ADDENDUM #3

Re: Harrisburg Area Community College

RLAC Theater and Prototype Toilet Room Renovations

Solicitation #RFB15-10

A9.0.1

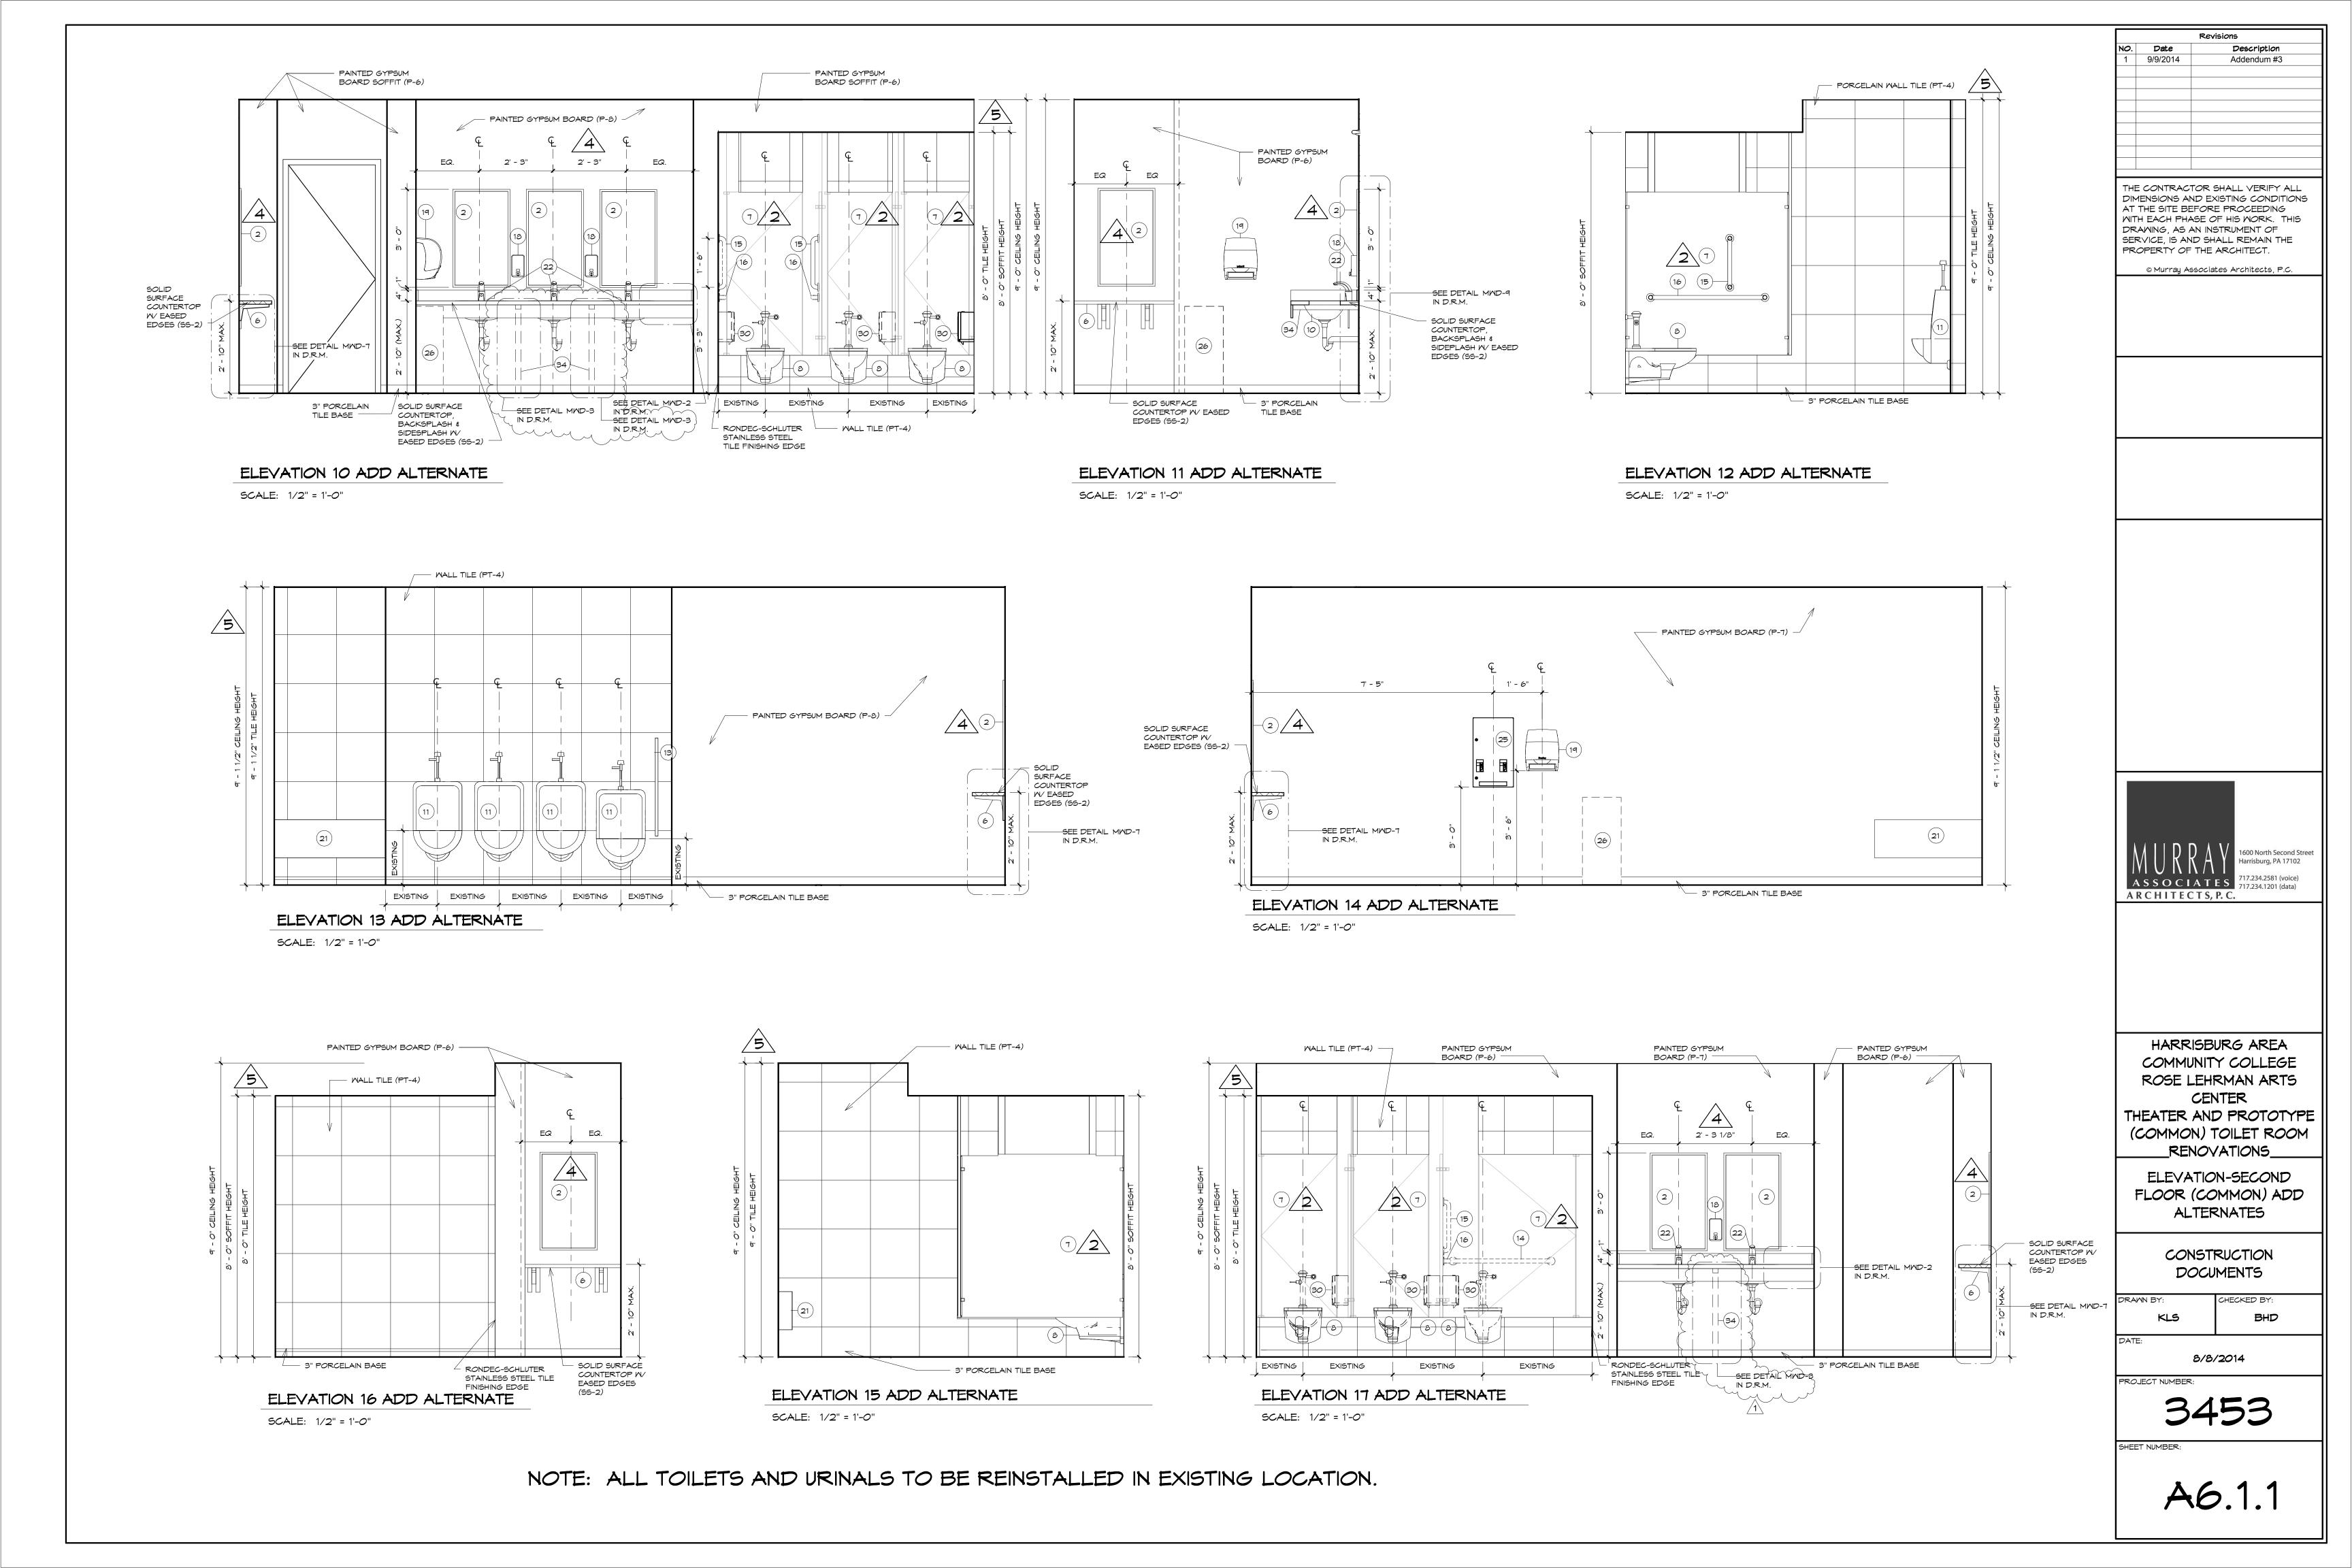
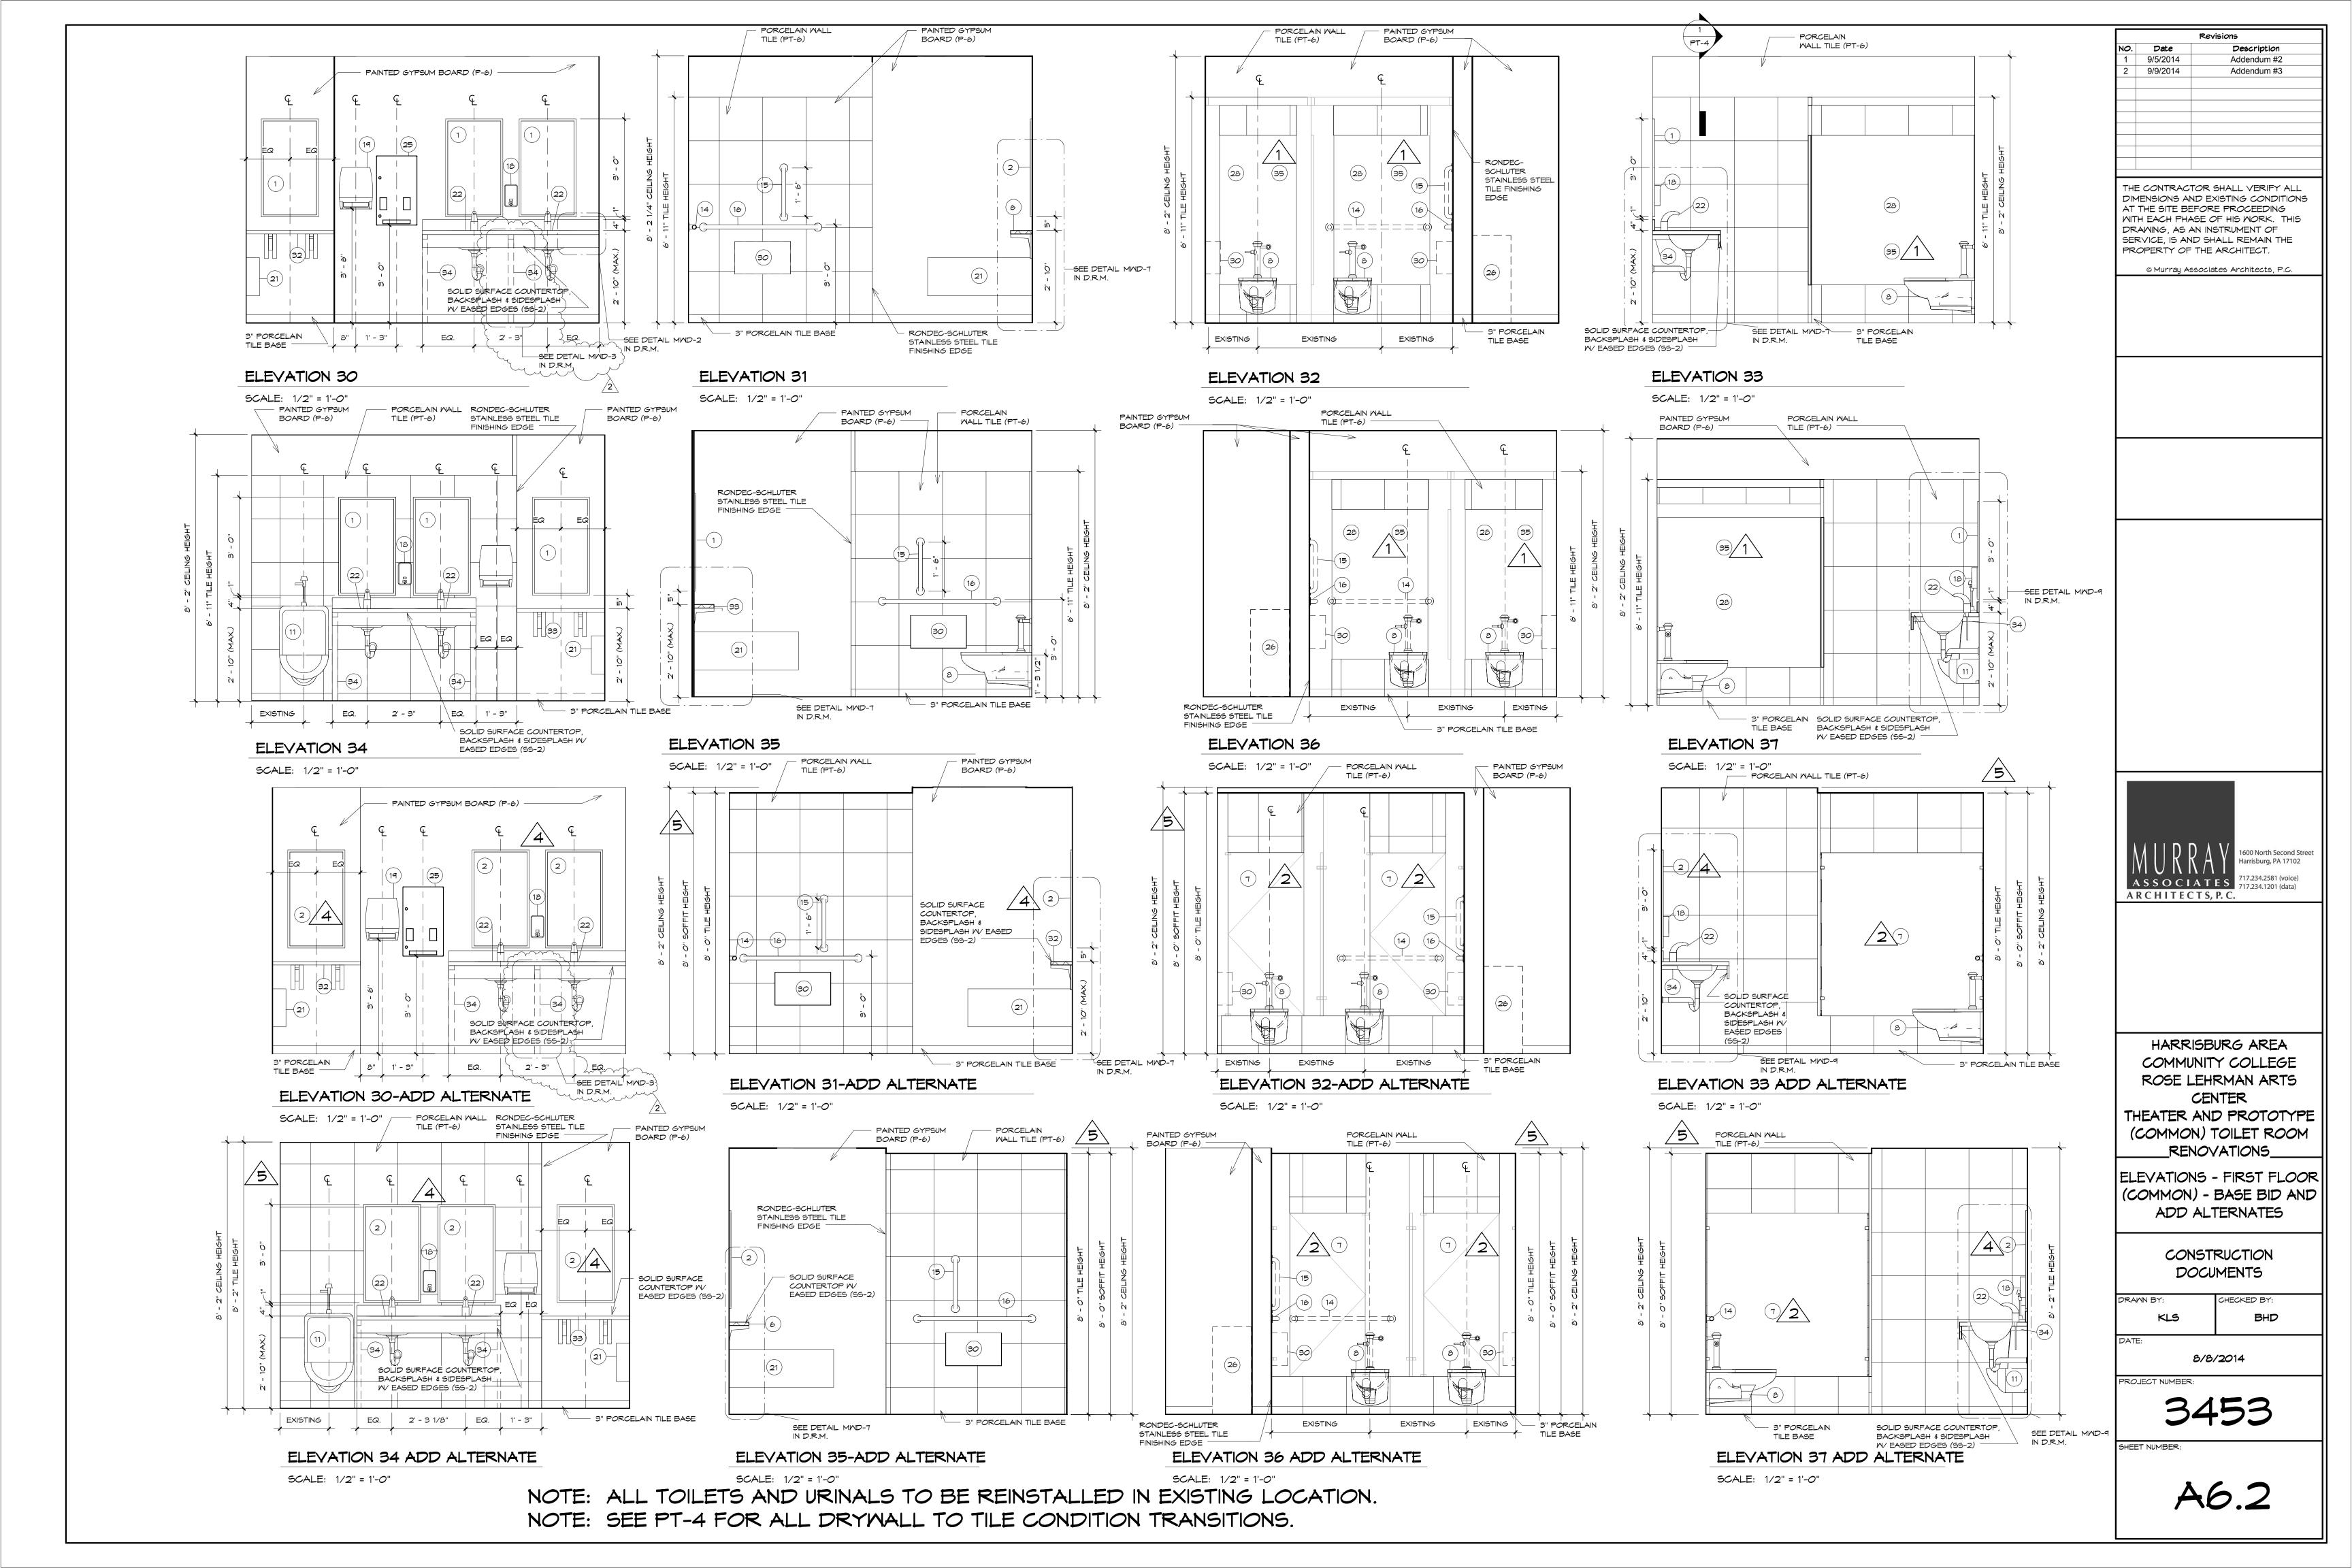
- INSTALL 3" X 5" ANGLE BETWEEN JOISTS. WELD BOTH ENDS

INSTALL 3" X 5" ANGLE BETWEEN
JOISTS. WELD BOTH ENDS
